Amendments To The Drawings:

REMARKS/ARGUMENTS

FIG. 2A

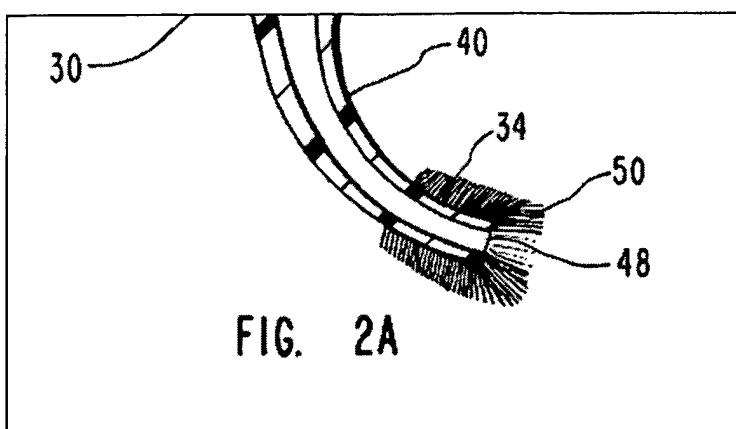
Paraphrased, claim 1 now claims an applicator for liquids or gels. The claimed applicator is also claimed to have bristles that are *within* the dispensing orifice, which is a feature that is not disclosed in the Fischer reference. In fact, as shown below, every embodiment of the Fischer reference shows bristles that are on the exterior or outside surfaces of a dispensing tube.

Fig. 1

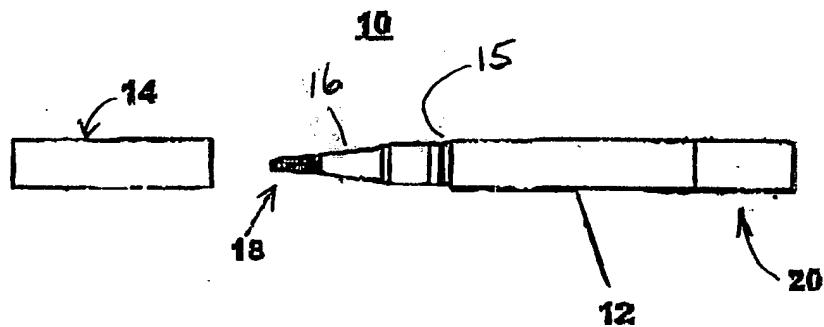
The drawings were objected to because reference numeral 15 was not clearly indicated and leader lines were missing for reference numerals 14, 20, 18, 20 and 29. The Examiner's objections to the drawings are believed overcome by the revisions to FIG. 1 and by new FIG. 2.

In response to the Examiner's drawing objections, the applicant has provided an amended FIG. 1, wherein leader lines are provided for reference numerals 14, 15, 16 and 20. The applicant has also provided a new FIG. 2 on a new drawing sheet.
